**Re: 2 Wells, 11,000-Gallon Tank, & Residual Maintenance ([PR#90-2024](#))
Willamette Hazelnut, Inc. (PWS ID# [95718](#))
Conditional Approval**

Willamette Hazelnut (PWS #095718)
Conditional Approval PR #90-2024 – Two wells, 11,000-gal tank, residual maintenance
September 17, 2024

Description of facilities reviewed under Plan Review #90-2024

Well #2 (SRC-AB) Davis Well photos received 8-28-24 – note cracked slab around well casing:

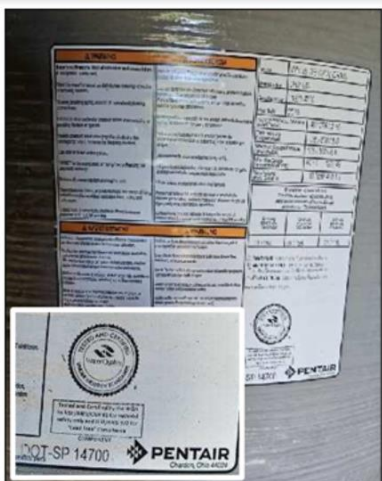
The construction of well #2 (SRC-AB) called the “Davis Well” could not be verified and no well log could be found. Therefore, the Davis Well cannot be approved as a drinking water source without further verification of its construction (e.g., verify the presence of annular grout seal, casing depth, static water level, etc.). A well driller may be able to assist with this verification. If the well’s construction cannot be verified, it may ultimately have to be reconstructed or physically disconnected from the rest of the system. **If the Davis well remains connected, monthly source assessment coliform monitoring should begin immediately due to the proximity of a pond within 240-ft of the well.**

The Davis well (or any other water well) will need to be **constructed or reconstructed in accordance with Oregon Water Resources Department (OWRD) general standards** for the construction and maintenance of water wells in Oregon as prescribed in OAR chapter 690, divisions 200 through 220, viewable online at:
<https://www.oregon.gov/owrd/Documents/Ch%20690%20Div%20200;%2020230206.pdf> ;
